ORDINARY MEETING 16 DECEMBER 2014	5.11
--	------

RECONFIGURING A LOT (1 LOT INTO 19 LOTS) - L100 GORGE ROAD,
MOSSMAN GORGE

Jenny Elphinstone: ROL 396/2014: 429208

<u>PROPOSAL:</u>	RECONFIGURING A LOT (1 INTO 19 LOTS AND ROAD)
<u>APPLICANT:</u>	DEPARTMENT OF ABORIGINAL & TORRES STRAIT ISLANDER & MULTI-CULTURAL AFFAIRS (REMOTE INDIGENOUS LAND AND INFRASTRUCTURE PROGRAM OFFICE) C/- GILVEAR PLANNING PTY LTD PO BOX 228 BABINDA QLD 4861
<u>LOCATION OF SITE:</u>	L100 GORGE ROAD, MOSSMAN GORGE
<u>PROPERTY:</u>	LOT 100 ON RP911412
<u>LOCALITY:</u>	RURAL AREAS AND RURAL SETTLEMENTS
<u>PLANNING AREA:</u>	RURAL
<u>PLANNING SCHEME:</u>	DOUGLAS SHIRE PLANNING SCHEME 2008
<u>REFERRAL AGENCIES:</u>	NONE APPLICABLE
<u>NUMBER OF SUBMITTERS:</u>	NOT APPLICABLE
<u>STATUTORY ASSESSMENT DEADLINE:</u>	19 DECEMBER 2014
<u>APPLICATION DATE:</u>	11 SEPTEMBER 2014
<u>APPENDIX:</u>	<ol style="list-style-type: none"> 1. APPROVED PLAN(S) & DOCUMENT(S) 2. INFRASTRUCTURE CHARGES NOTICE

APPENDIX 1: PROPOSED PLAN(S) & DOCUMENT(S)

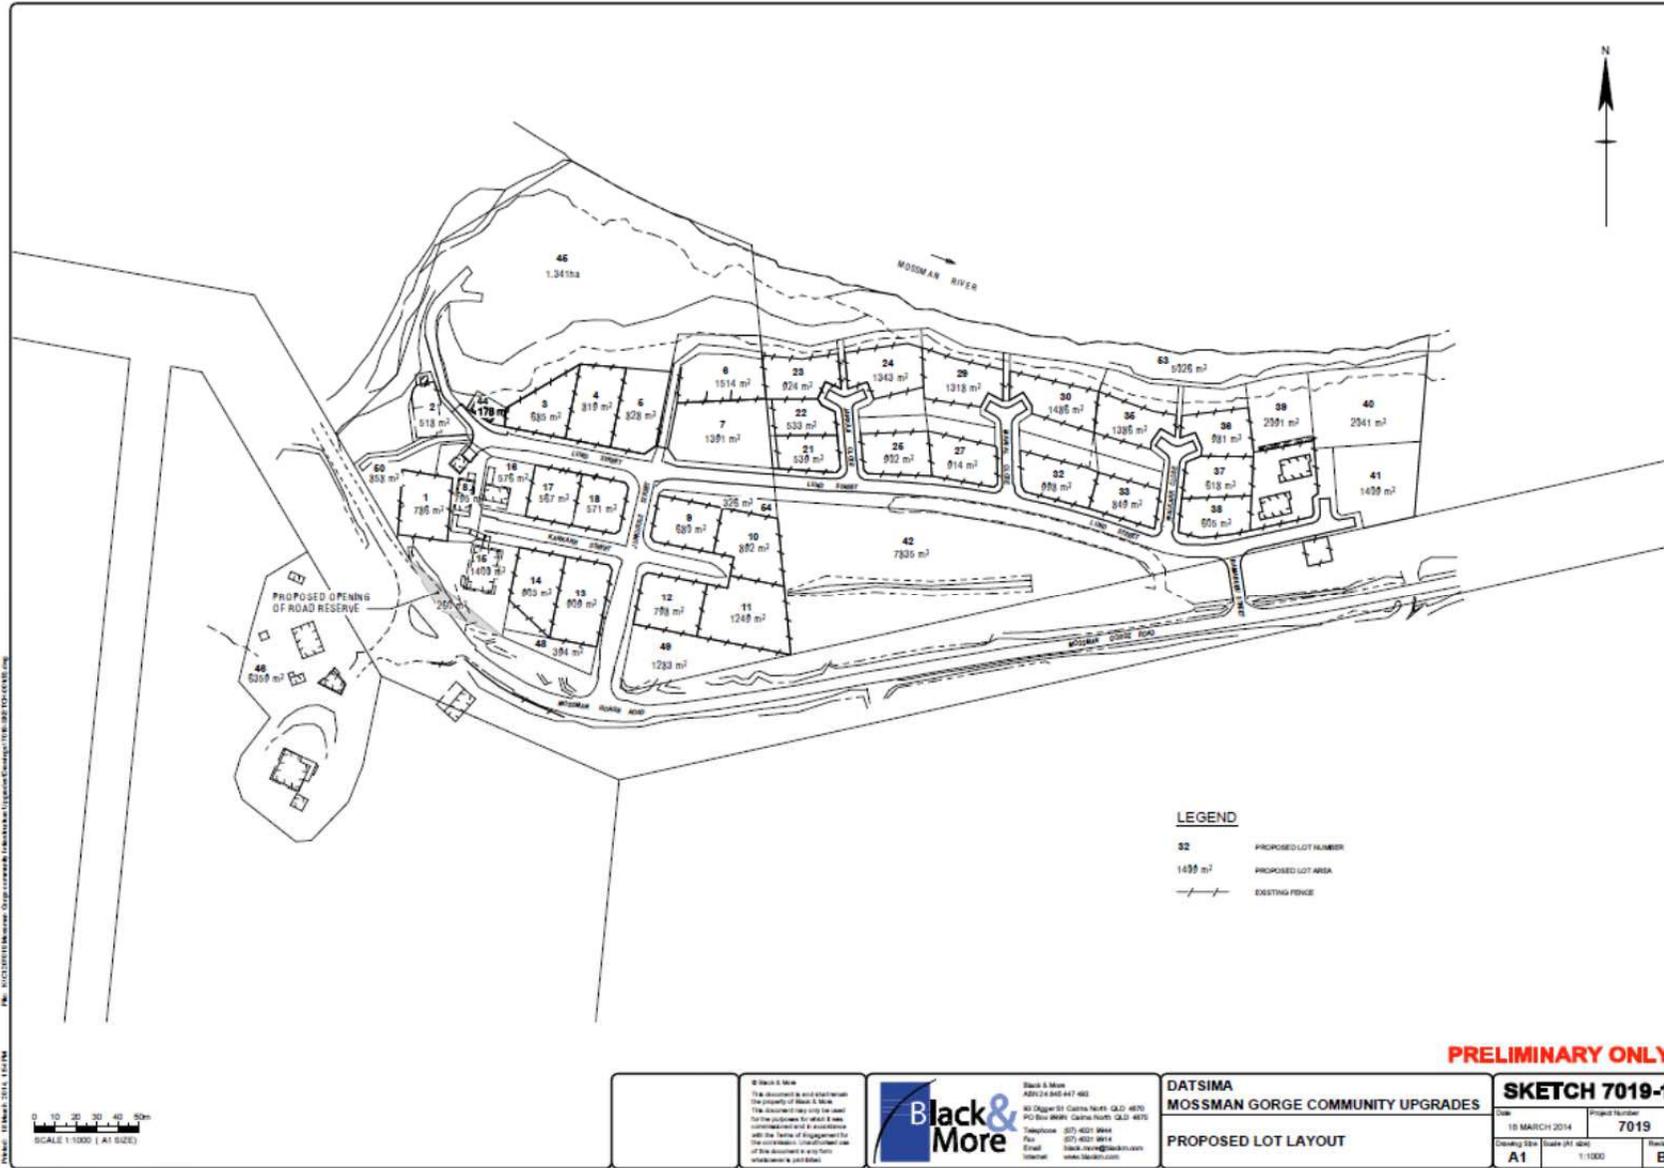
4. The street layout and design must be revised to comply with Queensland Streets and the *FNQROC Development Manual*, to the satisfaction of the Chief Executive Officer. In particular:
 - a. The street hierarchy nominated under Condition 3 above;
 - b. Following the endorsement of the Traffic Study required under Condition 5 inclusion of upgrades required to the existing road network;

- e. Remove the pedestrian links at the end of Jankaji Close, and Manjal Close and Walkarr Close and incorporate these areas into the neighbouring residential lots;

- f. Provision of a bus stop near Bamabubu Street and Mossman Gorge Road;
- g. A temporary vehicle turnaround at end of all roads where the length of road exceeds sixty (60) metres (i.e. maximum acceptable reversing distance for garbage truck) must be provided. The turning facility must be of sufficient size to turn around a garbage truck, either in a continuous forward movement or by a three-point turn. Alternatively, a common refuse collection area may be provided where suitably located. The location of any proposed common refuse collection area must be identified on the amended plans and approved by the Chief Executive Officer prior to the issue of a Development Permit for Operational Work;

- h. Revisit the design of the close, adjacent to Lot 39 and servicing Lots 40 and 41, on the eastern extent of the development. The current design is not supported. The road reserve width and road formation must be upgraded in all locations to comply with the requirements of the *FNQROC Development Manual* or be redesigned as a shared reciprocal access arrangement to Lots 39, 40, 41 and 53;

- i. Change the description of “Lot 53” that is a lot adjacent to the Mossman River from a freehold lot to land dedicated to the State as a Nature Reserve; and

- j. Note on the plan that Lot 42 is private community land;
- k. Compliance with the current version of Council’s *FNQROC Development Manual* – Road Network

- i. Stormwater drainage improvements on the eastern end of the proposed development are required. This includes, but is not limited to resolving the poor drainage in the area at the eastern end of the sports oval (proposed Lot 42);

- ii. The headwall adjacent to Lund Street needs to be relocated further from the road carriageway;
 - iii. The minimum size RCP to be used within the development is 375mm in accordance with the current requirements of the *FNQROC Development Manual*;

- iv. Structures must be provided to the western boundary of the land at proposed lots 21, 22 and 23 to mitigate inundation of lots 21, 22 and 23 from overland flows;
